# ENGINEERING BULLETIN

**Subject:** Instinct/Prestige Vent Terminations

**Date:** 7/27/2021 EB0065

Fig. 8 - Direct Vent - Sidewall Snorkel Termination of Vent and Combustion Air Piping

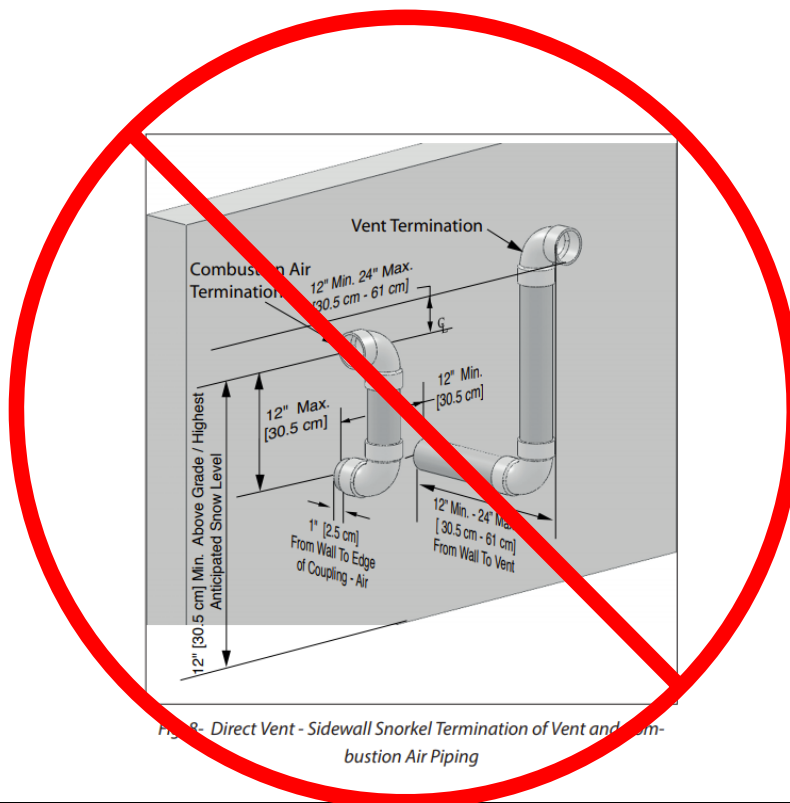
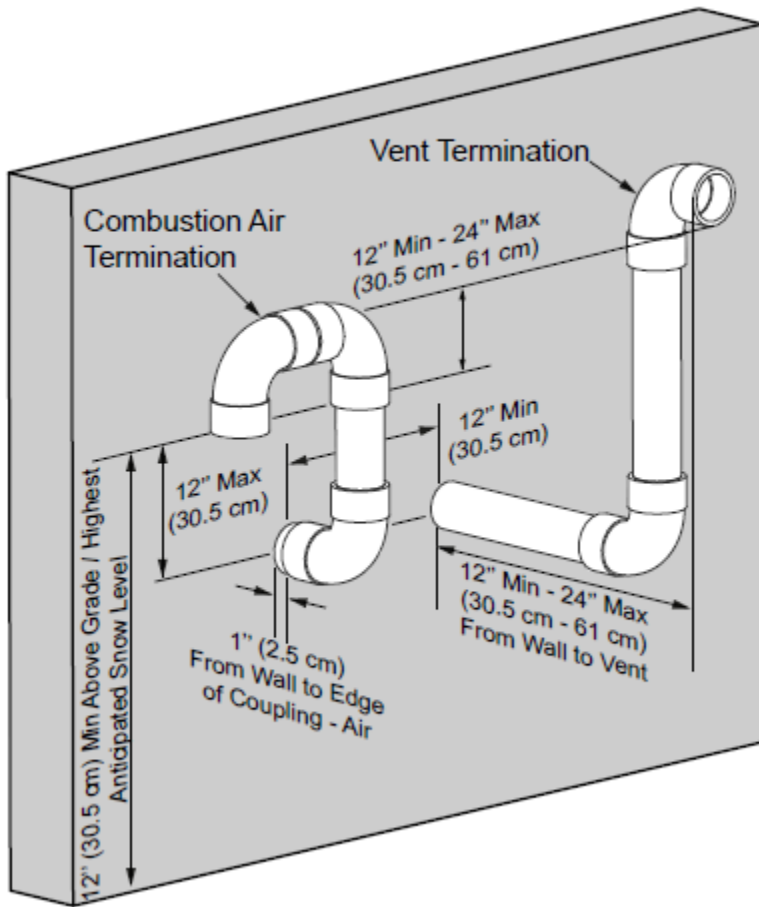
The Instinct Vent Guide and Prestige Vent Guide shows multiple installations where the combustion air termination comes out of the sidewall and terminates in the horizontal position (shown in Figs. 8, 12, 13). This should be shown with the combustion air termination with an additional 90° elbow pointing down toward the ground.

The Combustion Air Termination in the horizontal orientation may lead to rainwater getting into the piping under specific weather conditions.

Instinct and Prestige venting termination configurations in figs 8, 12, and 13 are no longer allowed. All affected installations should be adjusted so that the combustion air piping terminates with 180° bend with the intake opening facing the ground using two 90° elbows. The termination must be located 12" [30.5 cm] (18" [45.7 cm] in Canada) above the highest anticipated snow level.
